7 March 2025

Our Ref: P222_481-1 (ACCESS DA) DV

**ACCESSIBILITY CAPABILITY STATEMENT FOR SSDA SUBMISSION
PROJECT NAME: 3-5 HELP STREET, CHATSWOOD**

Drawing No.
 SSSA-1002

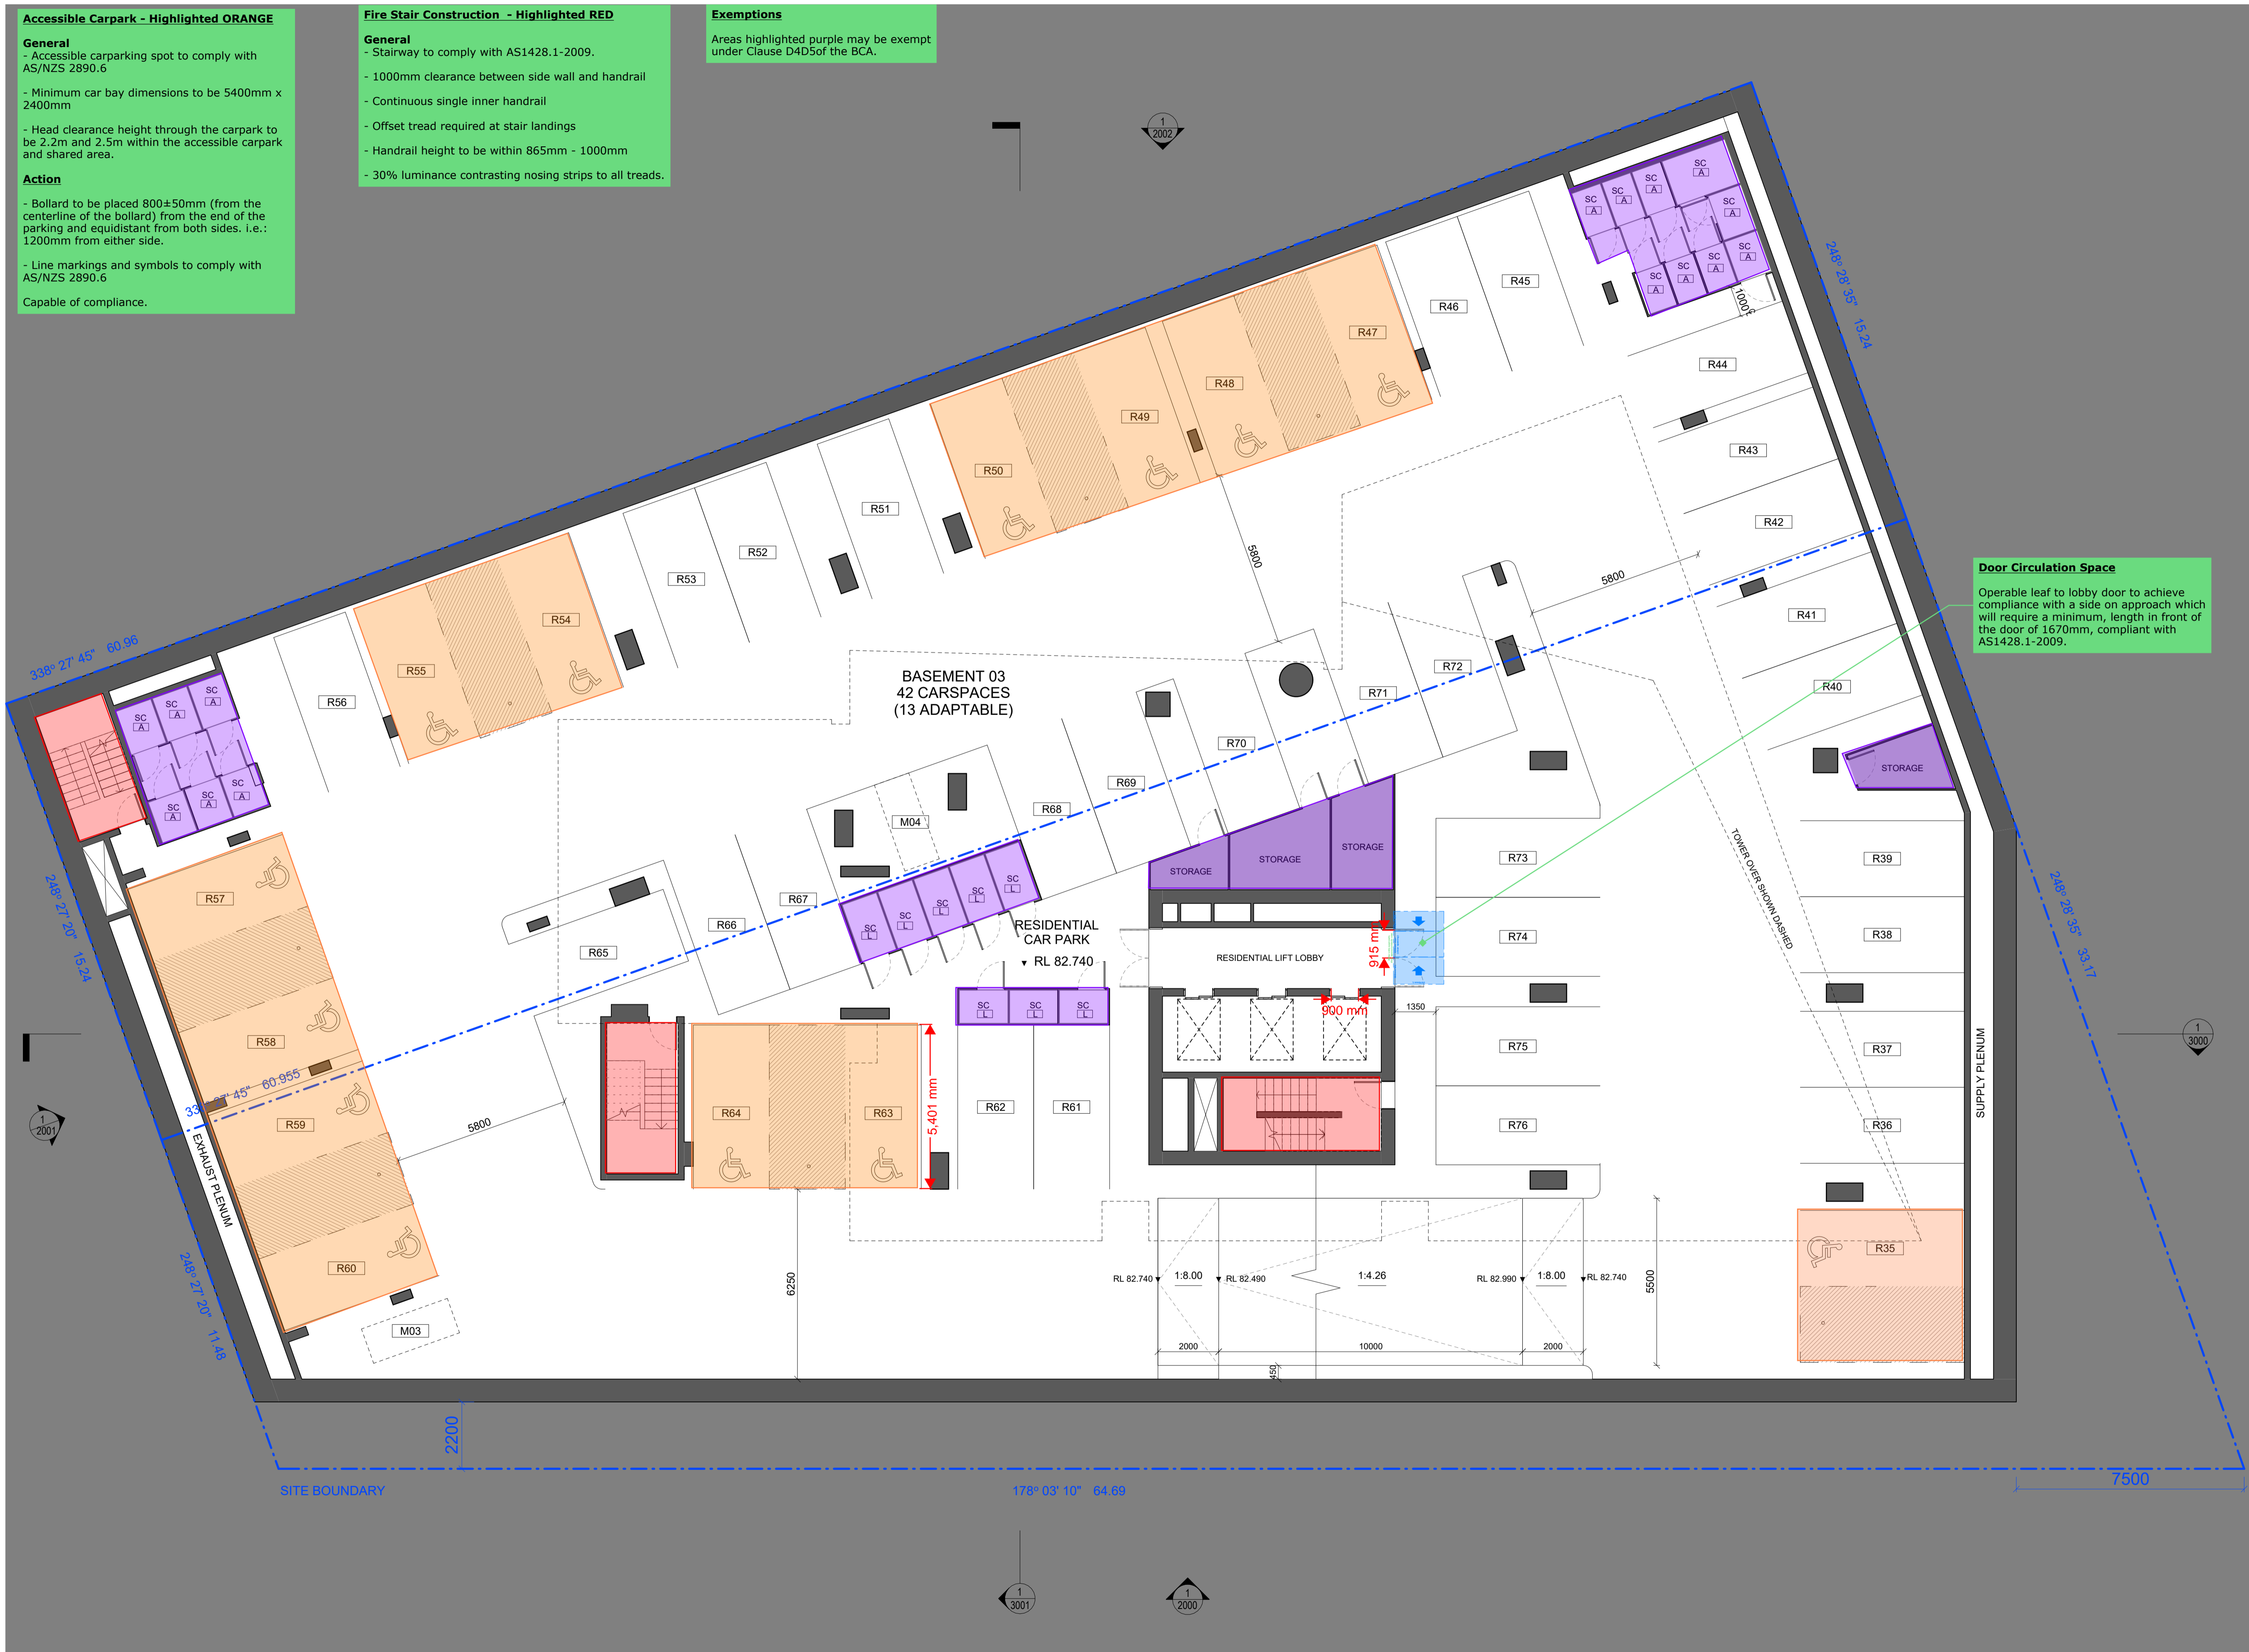
General
 - Accessible carparking spot to comply with AS/NZS 2890.6
 - Minimum car bay dimensions to be 5400mm x 2400mm
 - Head clearance height through the carpark to be 2.2m and 2.5m within the accessible carpark and shared area.

Action
 - Bollard to be placed 800±50mm (from the centerline of the bollard) from the end of the parking and equidistant from both sides. i.e.: 1200mm from either side.
 - Line markings and symbols to comply with AS/NZS 2890.6
 Capable of compliance.

General
 - Stairway to comply with AS1428.1-2009.
 - 1000mm clearance between side wall and handrail
 - Continuous single inner handrail
 - Offset tread required at stair landings
 - Handrail height to be within 865mm - 1000mm
 - 30% luminance contrasting nosing strips to all treads.

Operable leaf to lobby door to achieve compliance with a side on approach which will require a minimum length in front of the door of 1670mm, compliant with AS1428.1-2009.

Drawing No.
 SSSA-1003

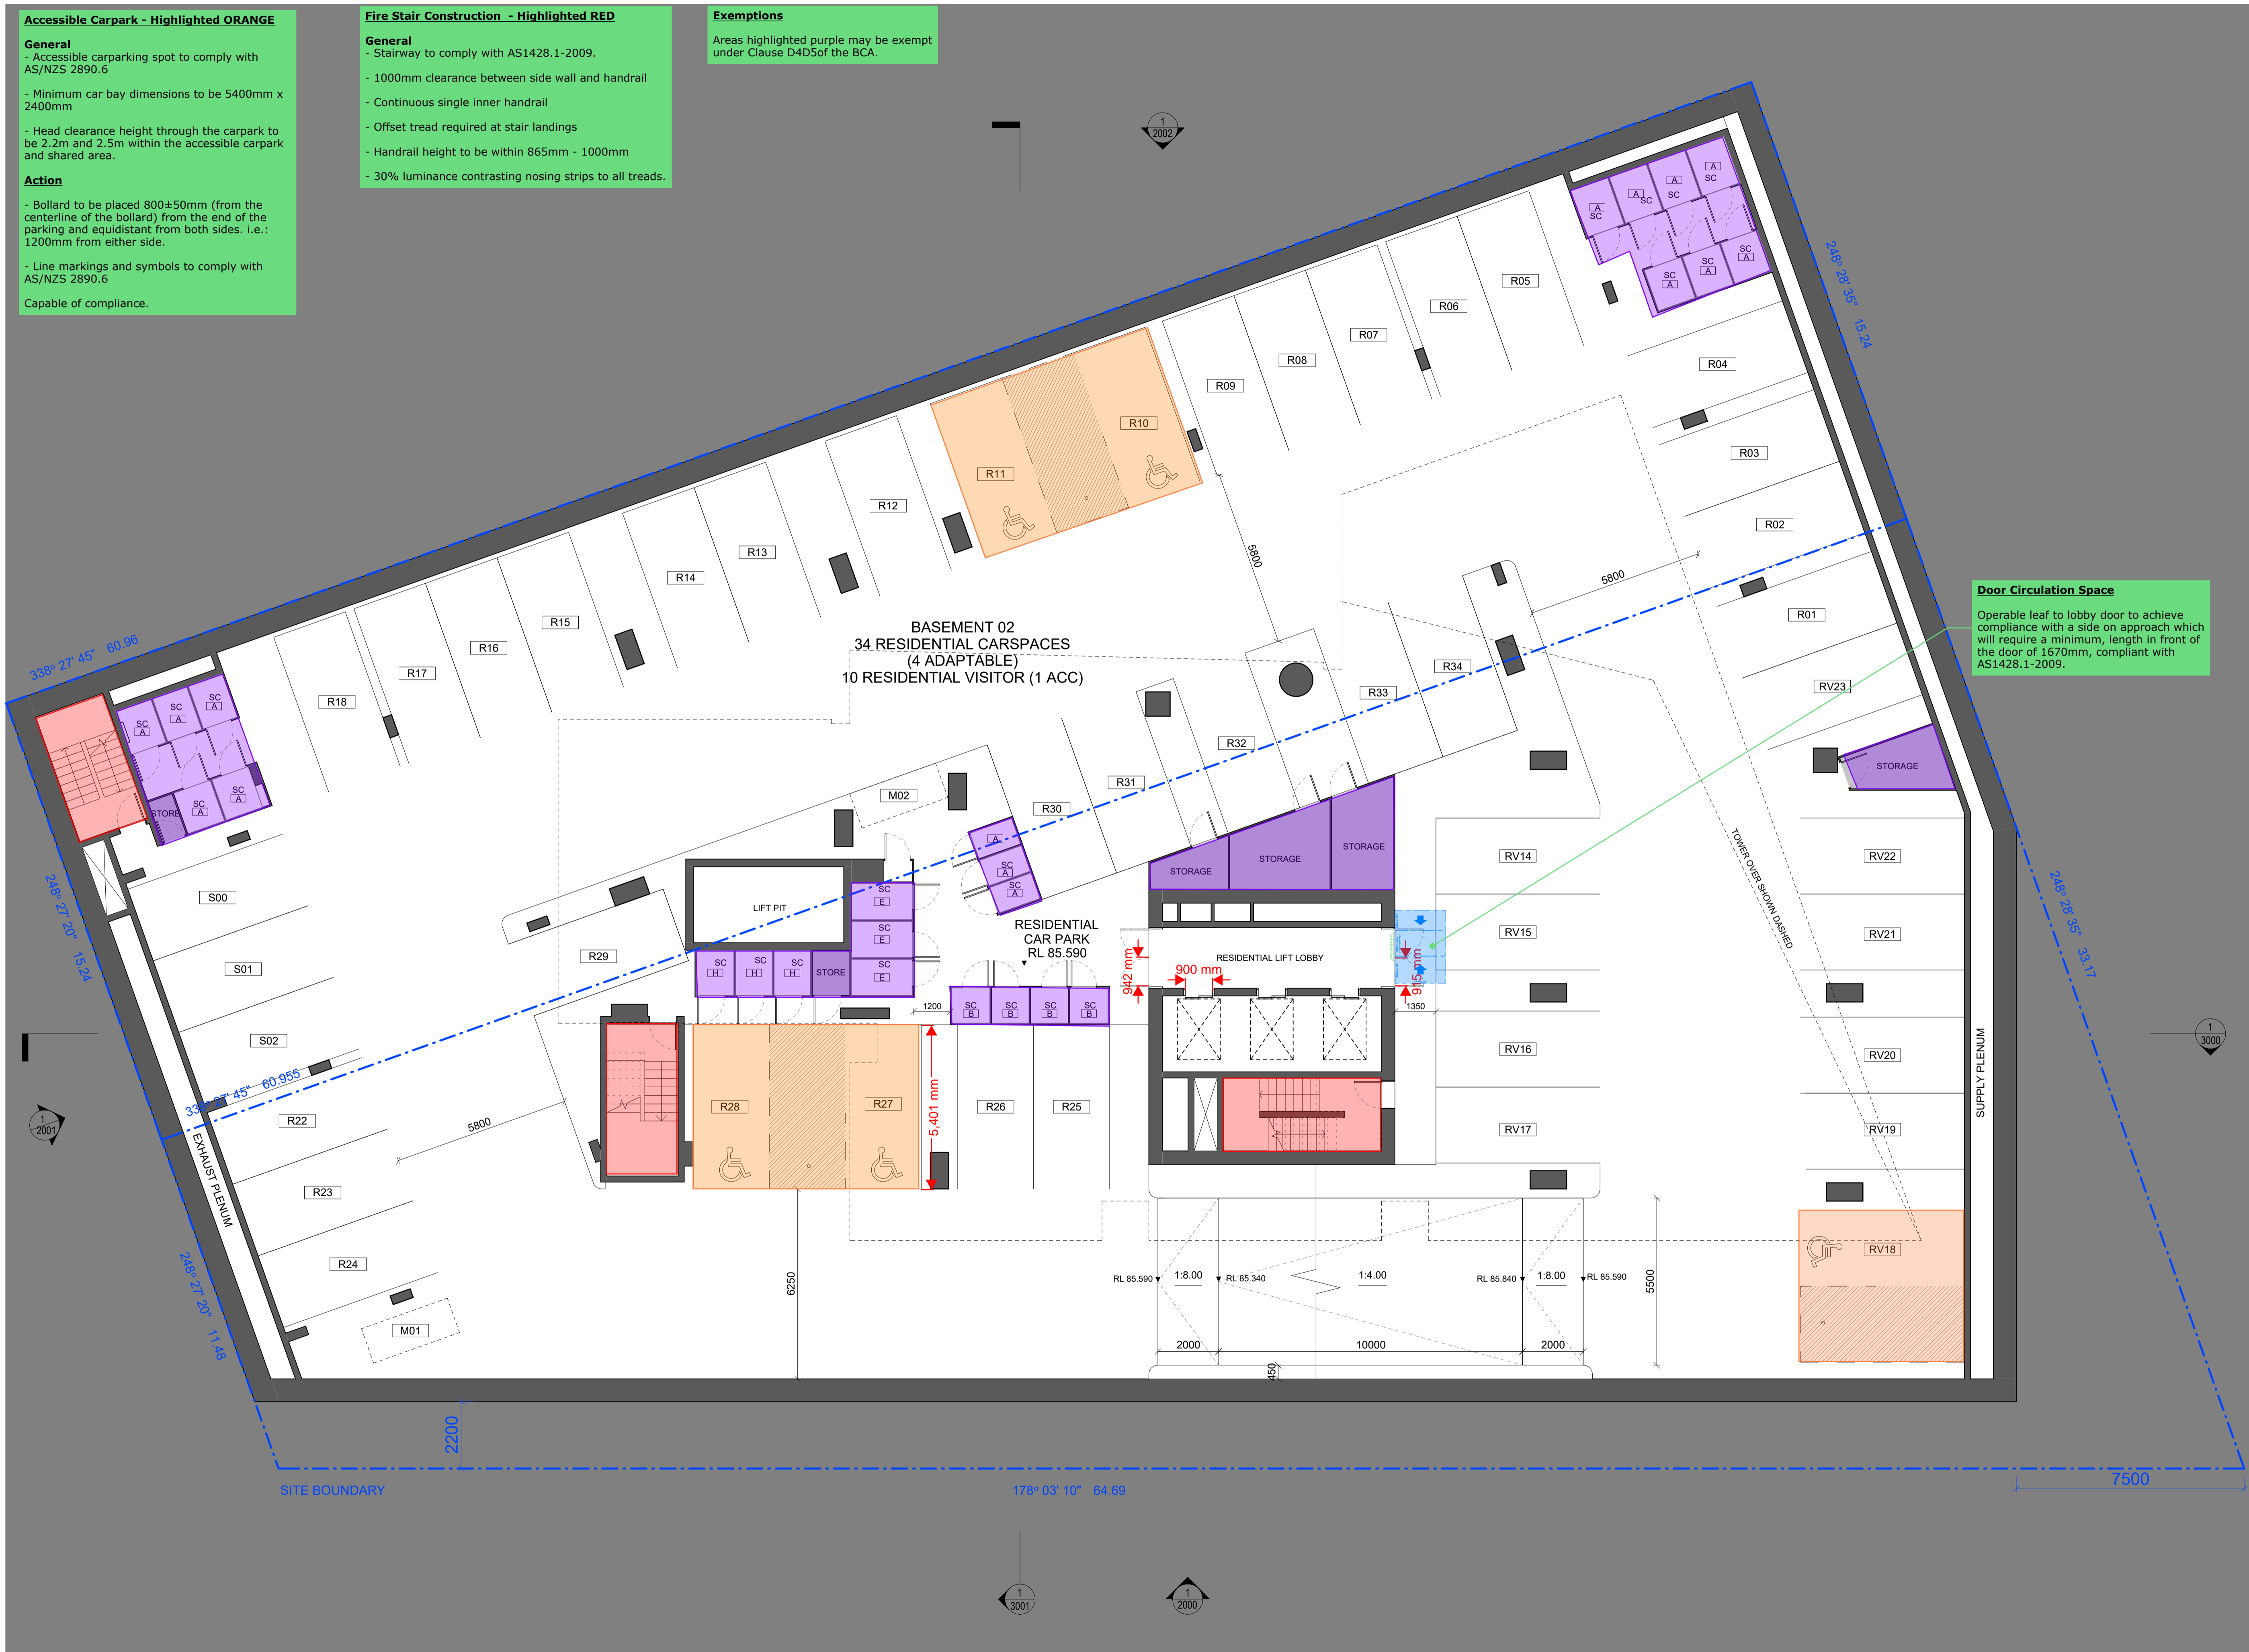
General
 - Accessible carparking spot to comply with AS/NZS 2890.6
 - Minimum car bay dimensions to be 5400mm x 2400mm
 - Head clearance height through the carpark to be 2.2m and 2.5m within the accessible carpark and shared area.

Action
 - Bollard to be placed 800±50mm (from the centerline of the bollard) from the end of the parking and equidistant from both sides. i.e.: 1200mm from either side.
 - Line markings and symbols to comply with AS/NZS 2890.6
 Capable of compliance.

General
 - Stairway to comply with AS1428.1-2009.
 - 1000mm clearance between side wall and handrail
 - Continuous single inner handrail
 - Offset tread required at stair landings
 - Handrail height to be within 865mm - 1000mm
 - 30% luminance contrasting nosing strips to all treads.

Door Circulation Space
 Operable leaf to lobby door to achieve compliance with a side on approach which will require a minimum length in front of the door of 1670mm, compliant with AS1428.1-2009.
